CITY OF MOBILE
TIGER 2016 Project Phase Four- Dr. Martin Luther King Jr. Ave from NW of Butchers
Lane to Beauregard St
Project No. 2023-2045-01

ADDENDUM #2

This addendum includes the following: (1) revised contract language, (2) revised PROPOSAL form (Attachment "A"), (3) responses to remaining questions and (4) updated plan sheets (Attachment "C"). This addendum consists of a total of 93 pages, including the cover page.

SUMMARY OF PLAN SHEET CHANGES

REFERENCE PROJECT NO	FISCAL YEAR	SHEET NO
2023-2045-01 TIGER-FAUP-4917(250)	2025	401A

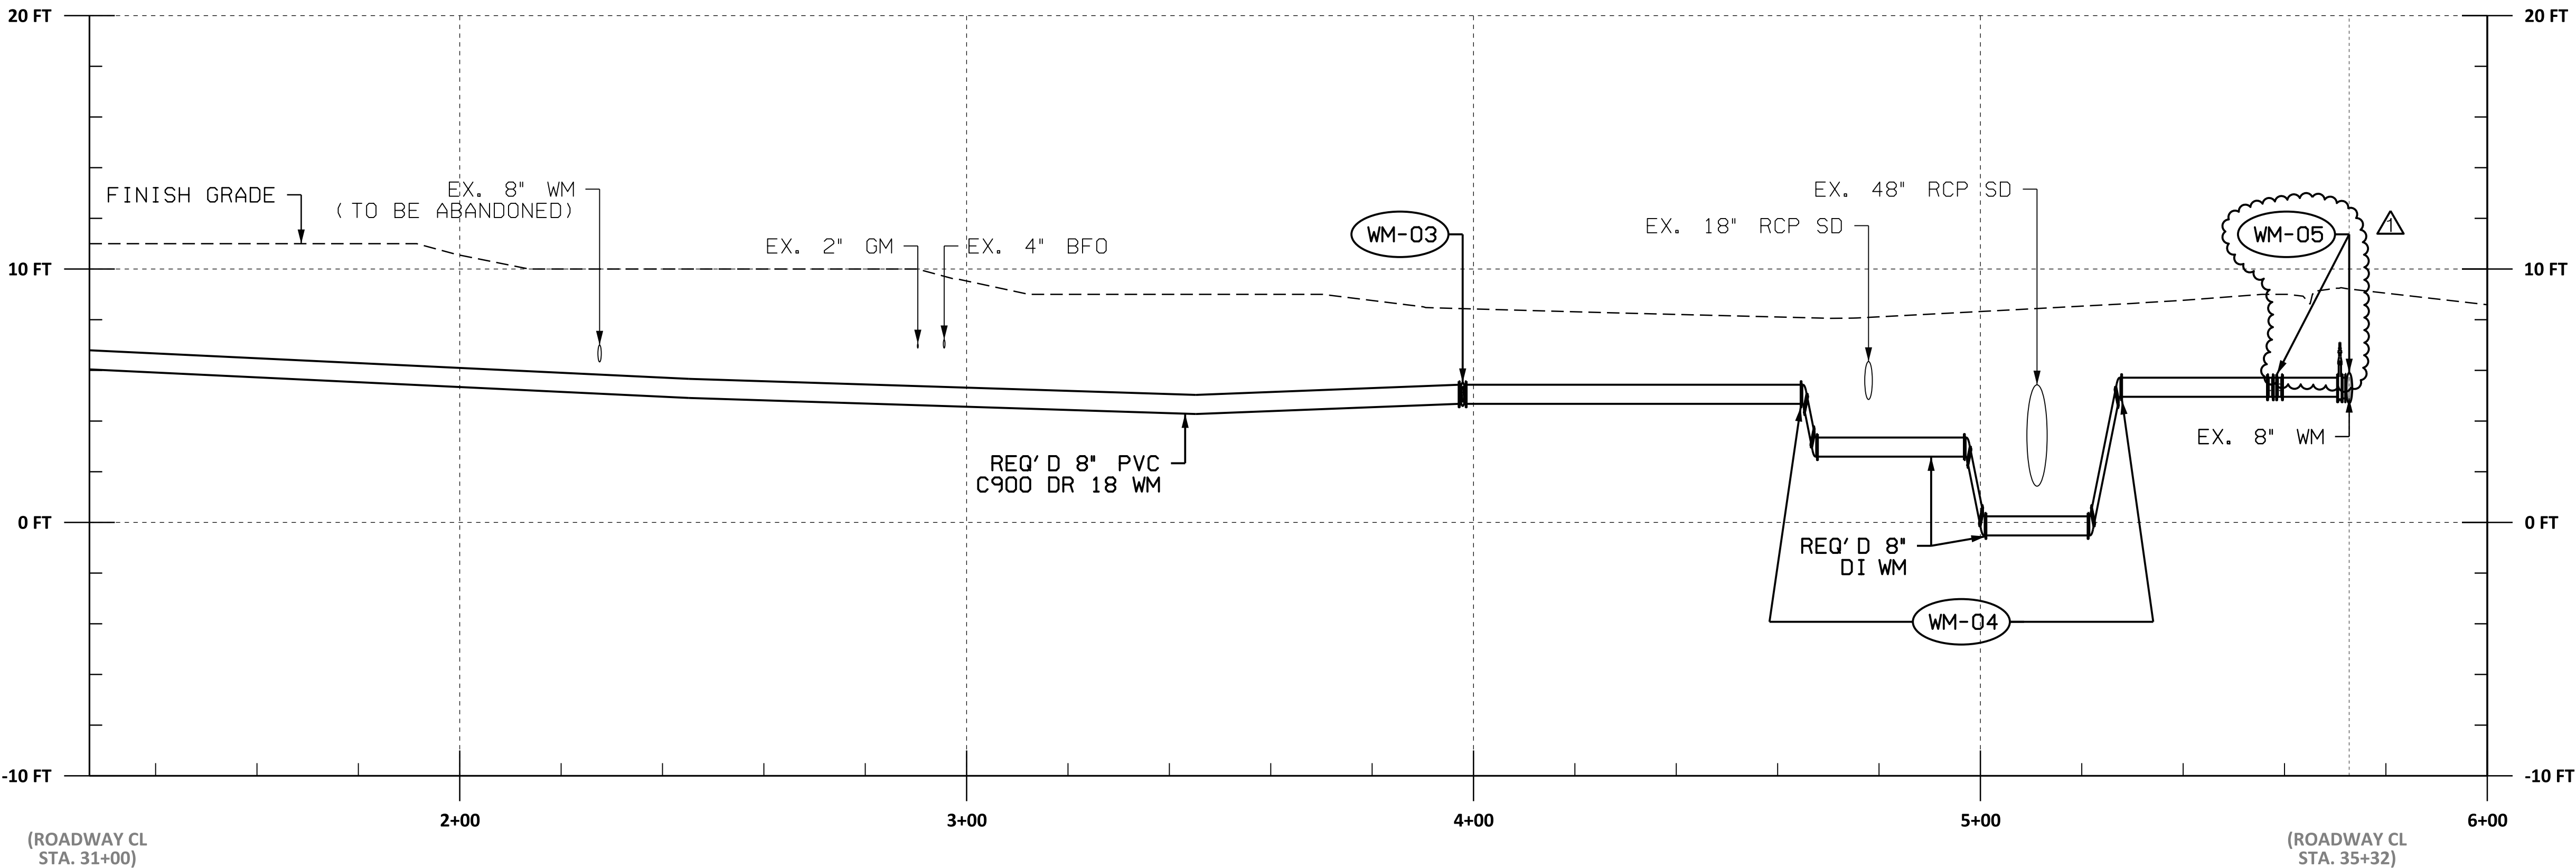
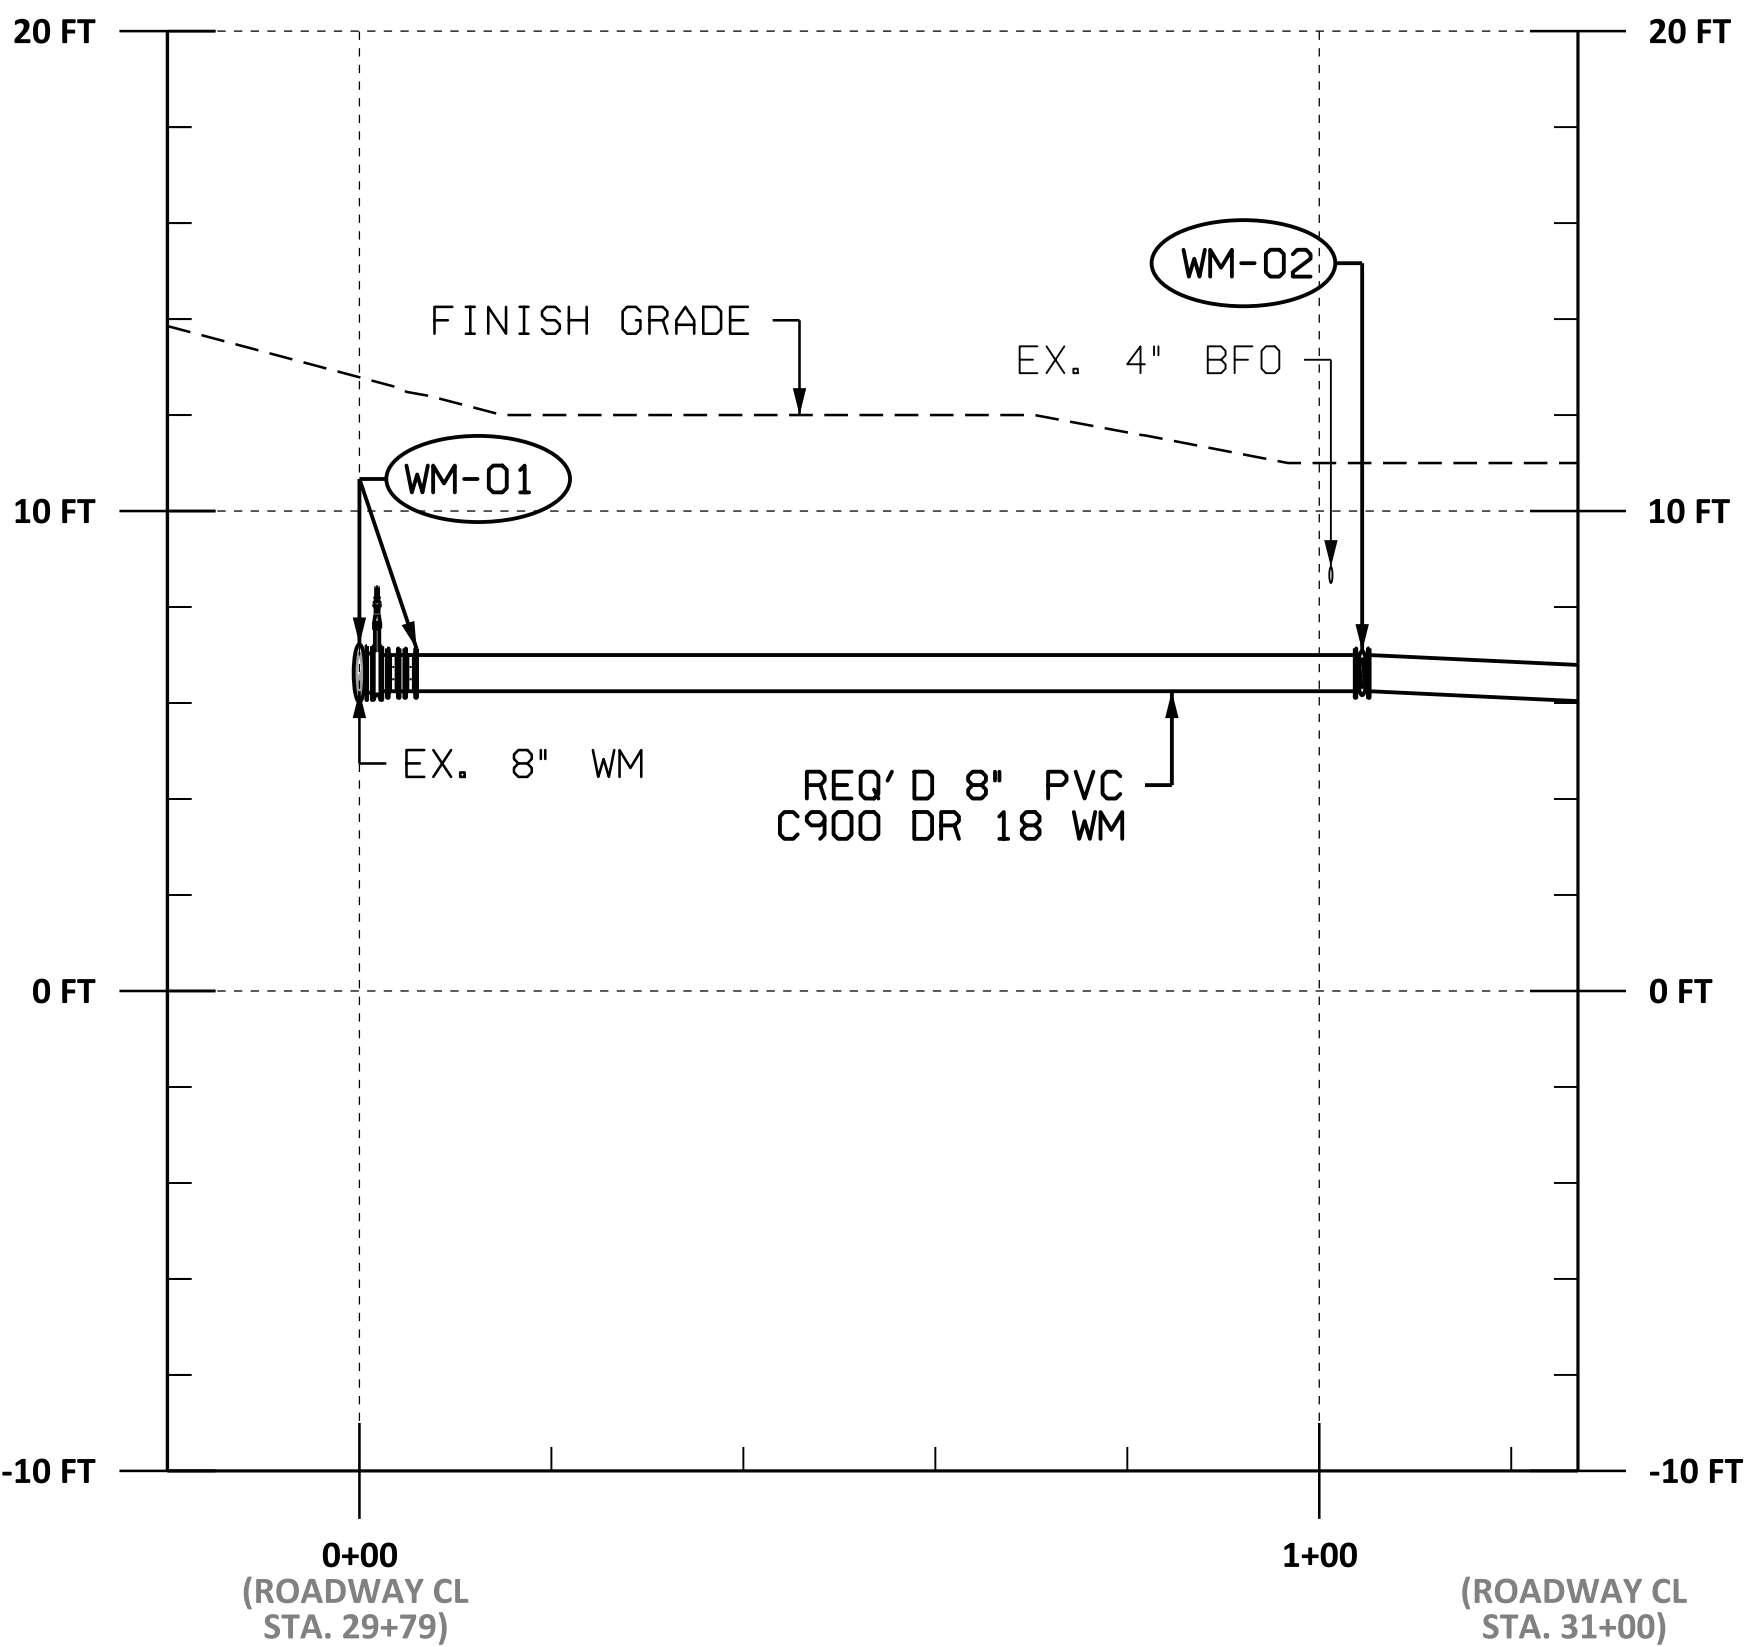
- Callouts WM-02 and WM-03 – Revised 6" retainer gland quantities
- **SHEET 401A**
 - Callout WM-05 – Modified leader arrows
- **SHEET 404**
 - Callout WM-11 – Added additional 6" gate valve, changed 8"x6" tee to 6"x6" tee, and revised retainer gland quantities

REFERENCE PROJECT NO	FISCAL YEAR	SHEET NO
2023-2045-01 TIGER-FAUP-4917(250)	2025	405

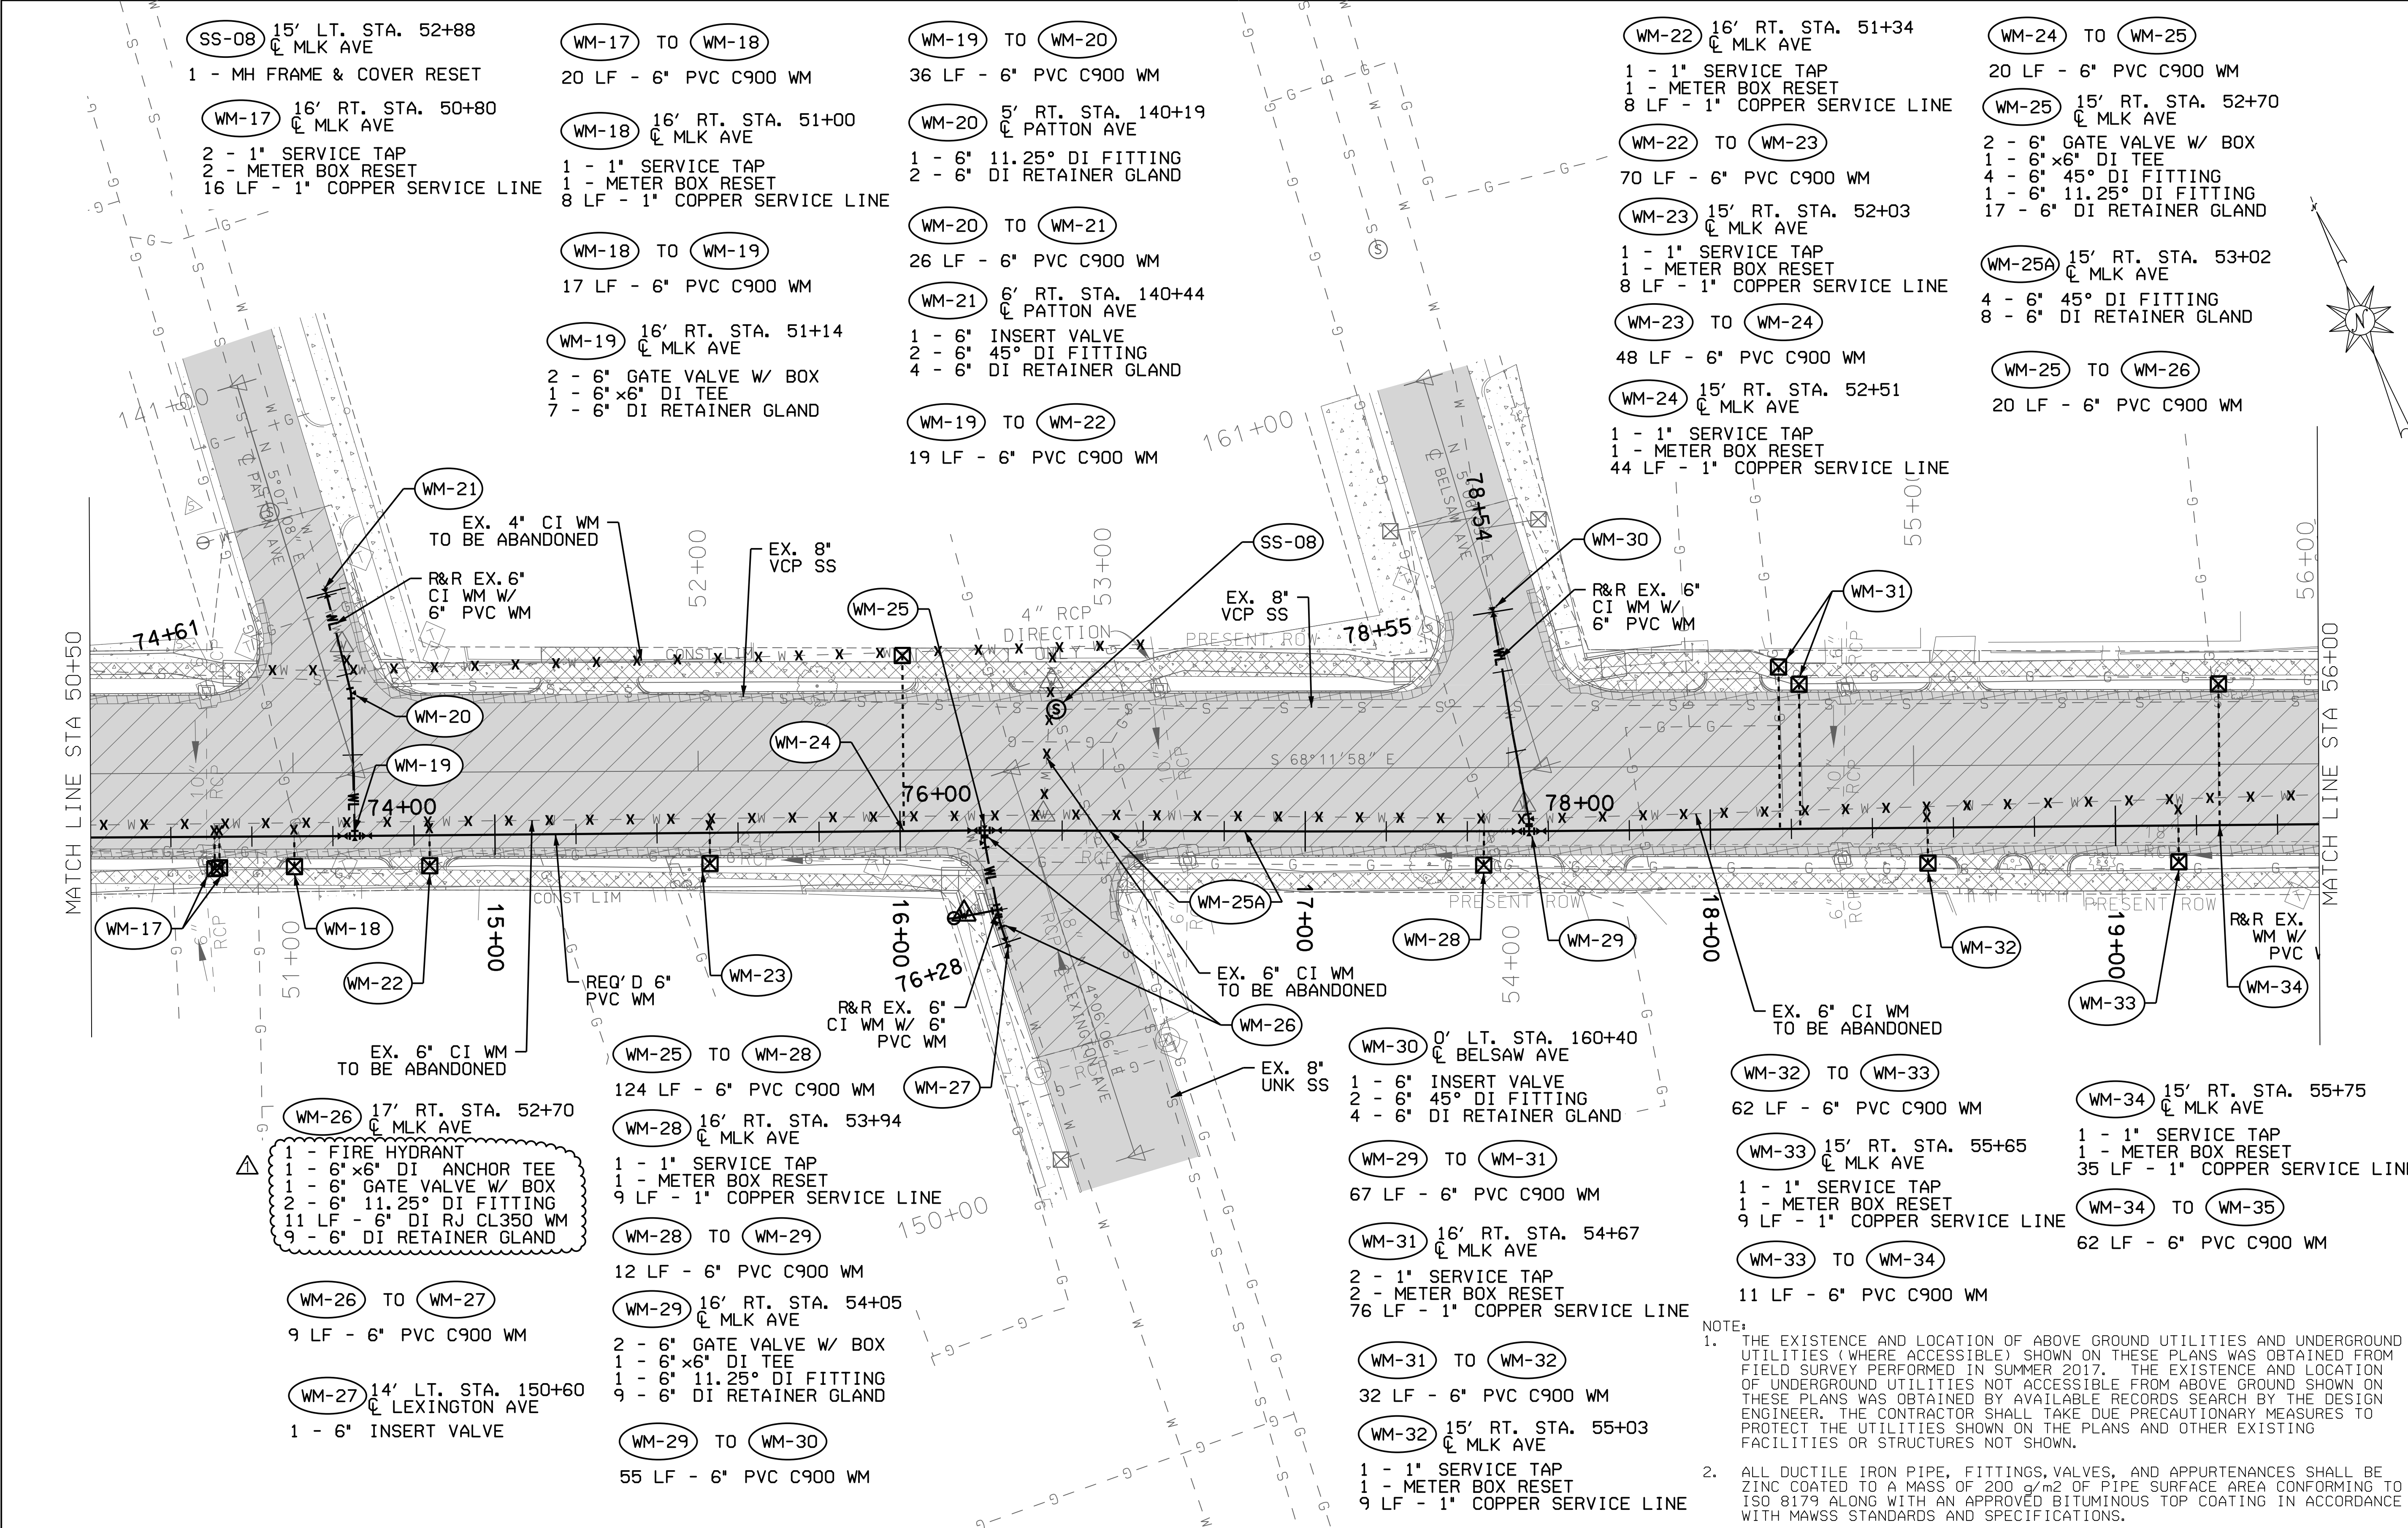
- **SHEET 405**
 - Callout WM-26 – Added 1 6" 11.25° fitting and revised retainer gland quantities
- **SHEET 406**
 - Callout WM-42 – Revised retainer gland quantity
